# Ultra Electronics SERVICE BULLETIN

## SERVICE BULLETIN No. C8E38-75-003

#### BLEED VALVE CONTROL UNIT

##### INTRODUCTION OF BVCU TYPE NUMBER C8E38-15

FM2 PCB Modification – C8E38-9 BVCU  
Figure 1

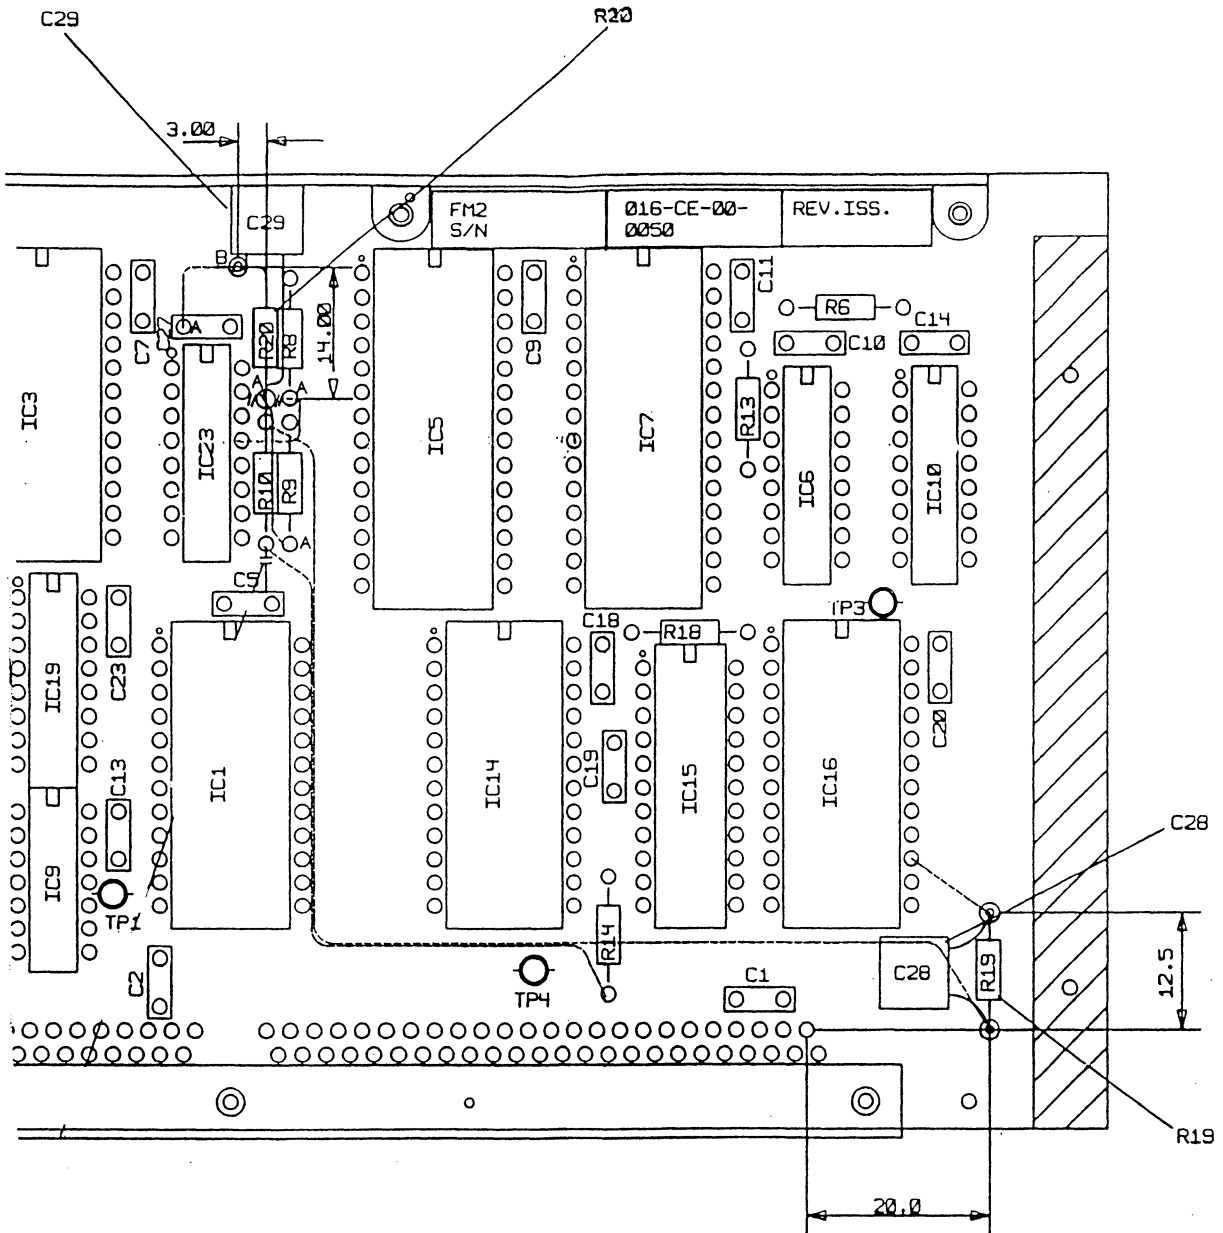
- (4) Refer to Fig. 1 and identify the place where the PCB tracking is to be cut.
- (5) Using an approved tool, cut the tracking in two positions to isolate the R10A and R20A pads. Ensure that you remove all traces of swarf.
- (6) Remove the conformal coating locally, as required, in the work areas.
- (7) Drill four 1.98mm ( $\pm 0.05$ mm) diameter holes in the positions shown in Fig. 1. Remove all traces of swarf.
- (8) Obtain three pins Pt. No. 23352-656-0-8, and one pin Pt. No. K3334-753-0-8 from the Mod. Kit and fit as follows :

Pins Pt. No. 23352-656-0-8 in positions C29B, R19A and R19B.  
 Pin Pt. No. K3334-753-0-8 in position R20A.

- (9) Obtain capacitor C29 and resistor R20 from the Mod. Kit.
- (10) Fit C29 and R20 as shown in Fig. 1. C29 must be bonded to the PCB using Dow Corning adhesive RVT3145 (or its equivalent). In addition, the lead of C29 which is soldered to pin 'A' must be sleeved using sleeving from the Mod. Kit.
- (11) Refer to Fig. 1 and identify the six links which are to be fitted. These are all on the solder side of the PCB and are :

FROM	TO	FROM	TO
C29/R20 (pin 'A')	R9A	R10 (pin 'A')	R14A
C29/R20 (pin 'B')	C27A	R10 (pin 'B')	R19B
IC23, pin 13	R8A	R19A	IC16, pin 15

- (12) Using wire from the Mod. Kit, cut the links to size and form them as shown in Fig. 1.
- (13) Solder the links in place.
- (14) Using Dow Corning adhesive RTV3145 (or its equivalent), tack each link to the surface of the PCB at about 25mm intervals.

Motherboard Modifications (1) – C8E38-9 BVCU  
Figure 2

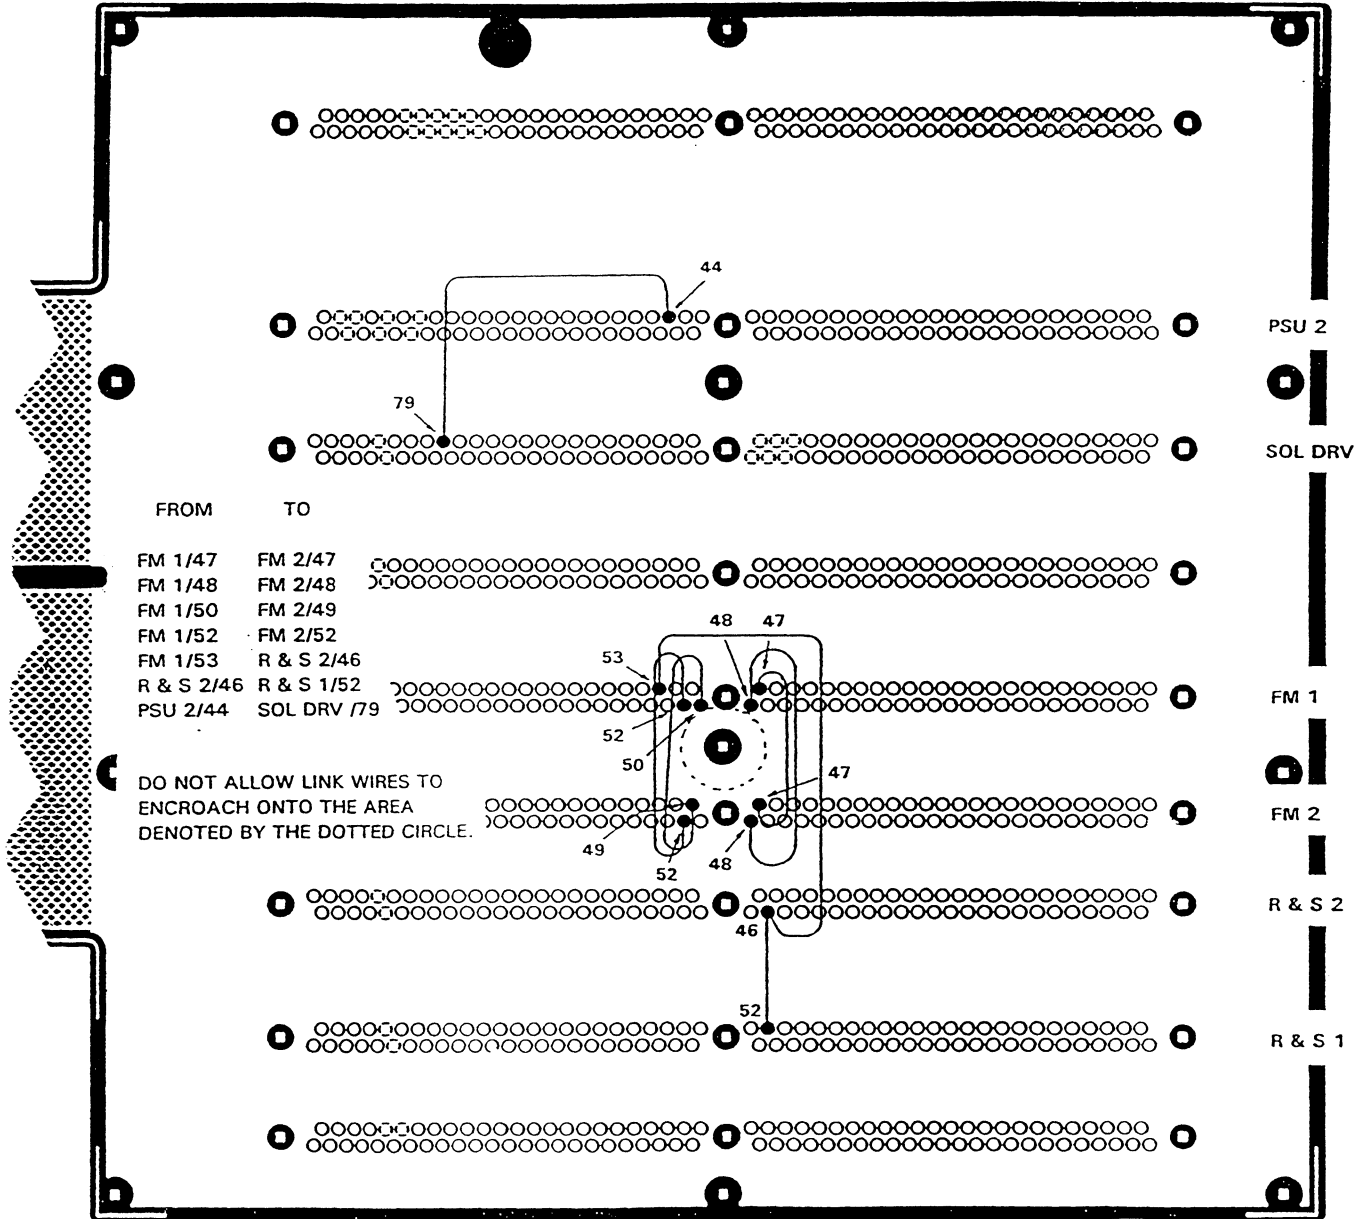
- (1) Refer to Fig. 2 in this Service Bulletin. On the motherboard, locate and identify the pin connections listed in the table in Fig. 2.
- (2) Refer to CMM 75-32-02, Repair page 601 and up, and familiarise yourself with the procedures for soldering work on conformally coated boards.

- (3) After removing the conformal coating locally around each pin connection, make up a set of links using Raychem Type 44, 7/0.0063 wire, Part No. 44A702926 (or its equivalent). Form the stripped ends of each link into tinned hooks of a size to fit over the protruding connector pins.

- (4) Solder the links to the connector pins, ensuring that a good fillet of solder is formed around each hook.
- (5) Using Dow Corning adhesive RTV 3145 (or its equivalent), tack each link to the motherboard surface at frequent intervals.

Motherboard Modifications (2) – All BVCUs  
Figure 3

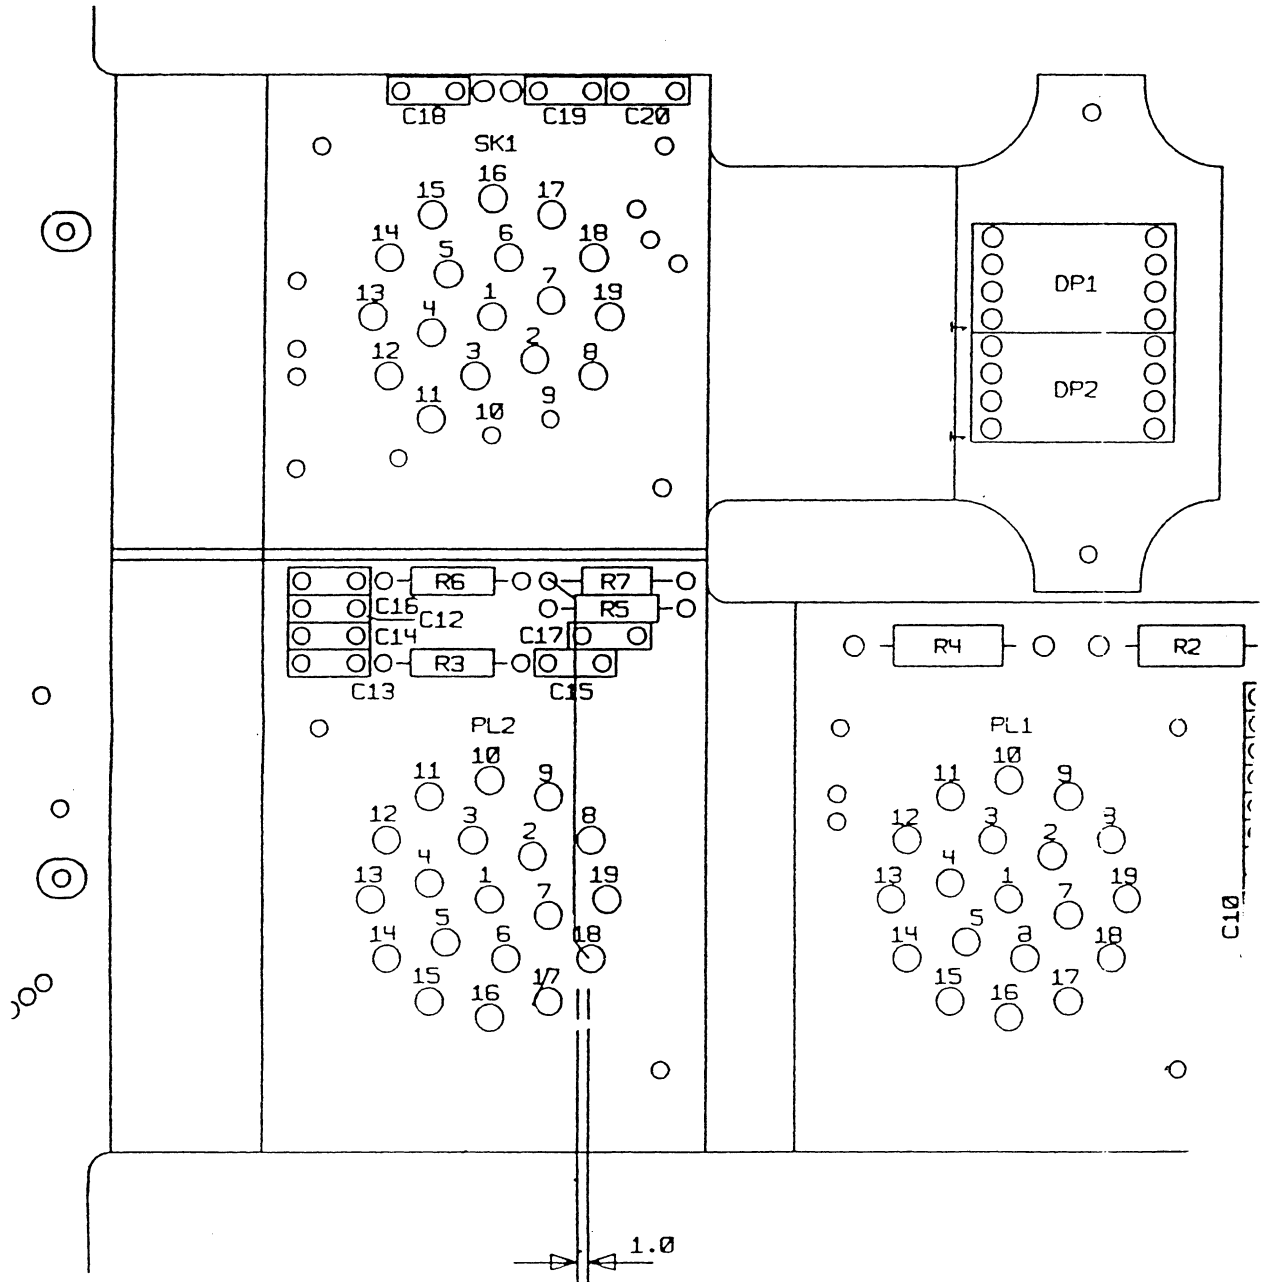
- (6) Refer now to Fig. 3 in this Service Bulletin, and locate resistor R7 and pins 17 and 18 of PL2.
- (7) Unscrew and discard the nine central polarising posts, one on each of the nine PCB connectors.

- (10) Using an approved tool, cut the PCB tracking between R7 and pin 17 of PL2, in the position shown in Fig. 3. Ensure that all traces of swarf are removed.

- (11) Also, cut the track between pins 33 and 42 of the R & S 1 connector. Ensure that all traces of swarf are removed.
- (12) Using a continuity tester, check that an open circuit exists between R7 and pin 17 of PL2 and between pins 33 and 42 of the R & S 1 connector.

- (13) Obtain the link wire from the Mod.Kit. Trim and form it as shown in Fig. 3, so as to link R7 to pin 18 of PL2.
- (14) Solder the link between R7 and pin 18 of PL2 and tack the link to the rigid board using Dow Corning adhesive RTV3145 (or its equivalent). Ensure that the adhesive is not applied on top of component pads.

- (15) Solder another link between pin 17 of the R & S 1 connector and pin 81 of the R & S 2 connector. Again, tack the link to the board.
- (16) Remove and discard the original labels and fit new labels from the Mod. Kit. Endorse the S/N label with the original assembly serial number. Endorse the Pt. No. label with the new part number as follows :

- (1) Refer to Fig. 3 in this Service Bulletin, and locate resistor R7 and pins 17 and 18 of PL2.
- (2) Unscrew and discard the nine central polarising posts, one on each of the nine PCB connectors.

- (5) Using an approved tool, cut the PCB tracking between R7 and pin 17 of PL2, in the position shown in Fig. 3. Ensure that all traces of swarf are removed.

- (8) Obtain the link wire from the Mod.Kit. Trim and form it as shown in Fig. 3, so as to link R7 to pin 18 of PL2.
- (9) Solder the link between R7 and pin 18 of PL2 and tack the link to the rigid board using Dow Corning adhesive RTV3145 (or its equivalent). Ensure that the adhesive is not applied on top of component pads.

FM2 PCB Modifications – C8E38-11 & -12 BVCUs  
Figure 4

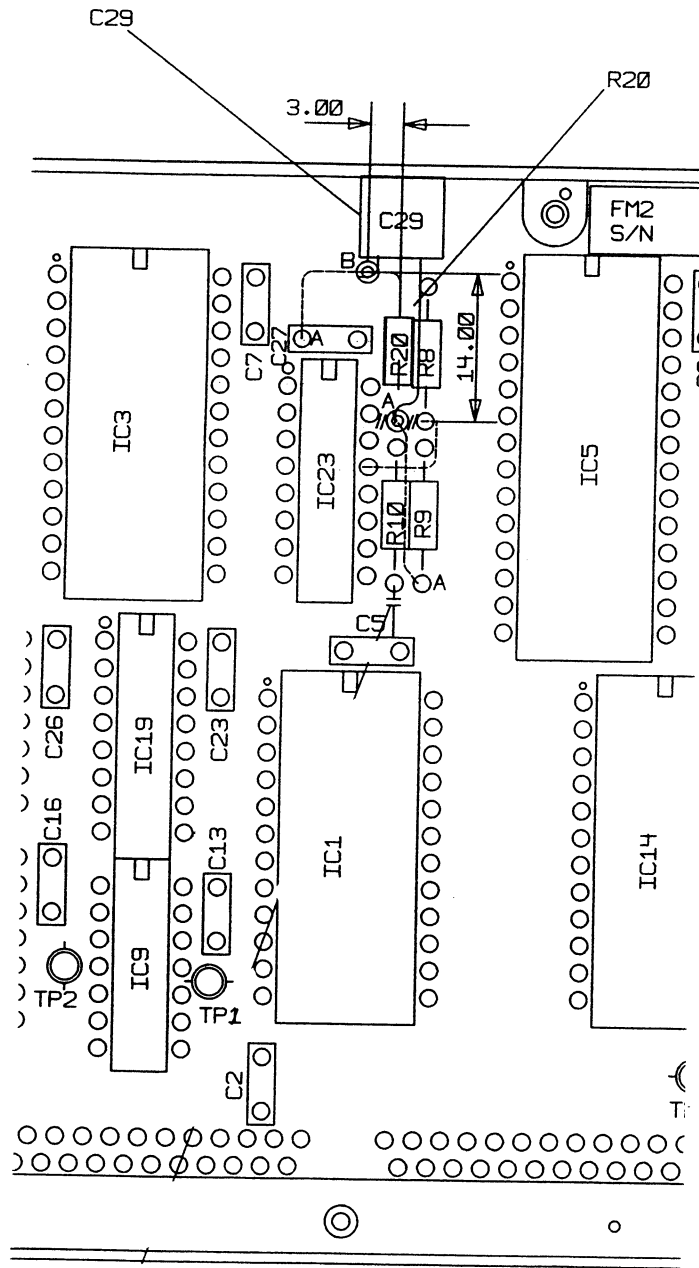
- (1) Refer to CMM 75-32-02, Repair, page 601 and familiarise yourself with the procedures for soldering work on conformally coated PCBs.
- (2) Using the latest issue of the self-test program 012-CE-00-0017, program the FM 2 PCB and test it.
- (3) Erase the program and re-program, using the latest issue of PL Document 017-CE-00-0057.
- (4) Refer to Fig. 4 and identify the place where the PCB tracking is to be cut.
- (5) Using an approved tool, cut the tracking in two positions to isolate the R12 and in one position to isolate the R10 pad. Ensure that you remove all traces of swarf.
- (6) Remove the conformal coating locally, as required, in the work areas.
- (7) Drill a 1.98mm ( $\pm 0.05$ mm) diameter hole in the position shown in Fig. 4. Remove all traces of swarf.

- (8) Obtain a pin Pt. No. 23352-656-0-8 from the Mod. Kit and fit it in the hole.
- (9) Obtain capacitor C29 and resistor R20 from the Mod. Kit.
- (10) Fit C29 and R20 as shown in Fig. 4. C29 must be bonded to the PCB using Dow Corning adhesive RVT3145 (or its equivalent). In addition, the lead of C29 which is soldered to pin 'A' must be sleeved using sleeving from the Mod. Kit.
- (11) Refer to Fig. 4 and identify the three links which are to be fitted. These are all on the solder side of the PCB and are :

FROM	TO
C29/R20 (pin 'A')	R9A
C29/R20 (pin 'B')	C27A
IC23, pin 13	R8

- (12) Using wire from the Mod. Kit, cut the links to size and form them as shown in Fig. 4.
- (13) Solder the links in place.
- (14) Using Dow Corning adhesive RTV3145 (or its equivalent), tack each link to the surface of the PCB at about 25mm intervals.
- (15) Remove and discard the original PCB labels and fit new labels from the Mod. Kit. Endorse the S/N label with the original PCB serial number. Endorse the Pt. No. label with the new part number, 017-CE-00-0050.
- (16) Repair the conformal coating as detailed in CMM 75-32-02, Repair, page 605. Add a layer of conformal coating over the new labels.
- (17) Store the modified FM 2 PCB in an anti-static bag until you are ready to install it into the BVCU.

- (4) Refer to Fig. 4 and identify the place where the PCB tracking is to be cut.
- (5) Using an approved tool, cut the tracking in two positions to isolate the R12 and in one position to isolate the R10 pad. Ensure that you remove all traces of swarf.

- (6) Remove the conformal coating locally, as required, in the work areas.
- (7) Drill a 1.98mm ( $\pm 0.05$ mm) diameter hole in the position shown in Fig. 4. Remove all traces of swarf.

- (8) Obtain a pin Pt. No. 23352-656-0-8 from the Mod. Kit and fit it in the hole.
- (9) Obtain capacitor C29 and resistor R20 from the Mod. Kit.
- (10) Fit C29 and R20 as shown in Fig. 4. C29 must be bonded to the PCB using Dow Corning adhesive RVT3145 (or its equivalent). In addition, the lead of C29 which is soldered to pin 'A' must be sleeved using sleeving from the Mod. Kit.

- (11) Refer to Fig. 4 and identify the three links which are to be fitted. These are all on the solder side of the PCB and are :

FROM	TO
C29/R20 (pin 'A')	R9A
C29/R20 (pin 'B')	C27A
IC23, pin 13	R8

- (12) Using wire from the Mod. Kit, cut the links to size and form them as shown in Fig. 4.
- (13) Solder the links in place.
- (14) Using Dow Corning adhesive RTV3145 (or its equivalent), tack each link to the surface of the PCB at about 25mm intervals.
- (15) Remove and discard the original PCB labels and fit new labels from the Mod. Kit. Endorse the S/N label with the original PCB serial number. Endorse the Pt. No. label with the new part number, 017-CE-00-0050.
